Report to Sydney West Joint Regional Planning Panel

JRPP No.	2015SYW183
DA No:	JRPP-15-1865
Proposed Development:	Residential flat building comprising 138 apartments
Development Type:	Capital Investment Value > \$20 million
Lodgement Date:	20 August 2015
Land/Address:	Lots 53-59, DP 14294 and Lot 2, DP 595267 1-11 Olive Street and 17-19 Alice Street, Seven Hills
Land Zoning:	R4 High Density Residential
Capital Investment Value:	\$31,252,522
Applicant:	Civic Properties Group Pty Limited
Report Author:	Rebecca Gordon, Senior Town Planner
Instructing Officers:	Judith Portelli, Manager Development Assessment Glennys James, Director Design and Development
Date Submitted to JRPP:	21 November 2016
Date Considered by JRPP:	15 December 2016

ASSESSMENT REPORT

Figure 5 Diagram showing the 3 parts of the building (Source: GM Architects 2015)

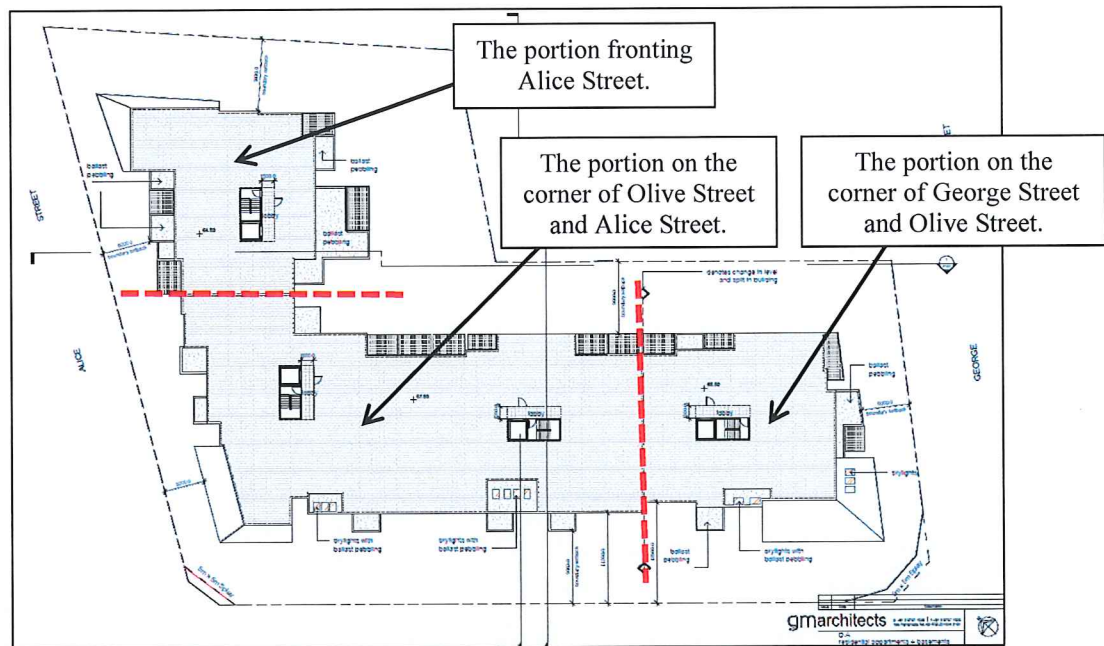
The building is made up of 3 distinct parts. There is the portion located on the corner of George and Olive Streets, the portion fronting Alice Street located adjacent to the northern boundary, and the largest section which is located on the corner of Olive and Alice Streets (see Figure 5). The roof plan included at **Attachment 4** also shows how the building is divided up into 3 parts.

- The portion of the building located on the corner of George and Olive Streets complies with the 20 m height limit except for the lift overrun
- The portion of the building fronting Alice Street, and located immediately adjacent to the northern boundary, is well under the 20 m height limit (by up to 1.5 m) except for a small portion of the lift overrun

- The portion of the building located on the corner of Olive and Alice Streets does not comply with the maximum height limit. When viewed from Olive Street, only the 2 lift overruns and a minor section of the roof top terrace exceeds the height limit. These encroachments are considered minor. The rear half of this portion of the building, however, exceeds the maximum building height by up to 2.5 m. This is due to there being an almost 3 m fall across the site. While the building has been stepped in response to the change in levels, it still results in an encroachment to the building height. The encroachment only includes the roof top terrace, the lift overruns and a small portion of the ceiling area of the upper floor units.

The portion of the building located on the corner of Olive and Alice Streets includes an exceedance to the building height by up to 2.5 m. The additional height is due to the slope of the land, is limited to a portion of the building only, and does not result in an additional floor level. The proposed number of storeys, being 6 in total, is consistent with other residential flat developments in the 20 m height limit area. The encroachment is also limited to the centre of the site and will have negligible shadow and amenity impacts on surrounding properties. For these reasons it is considered that the proposed variation to the height standard should be supported.
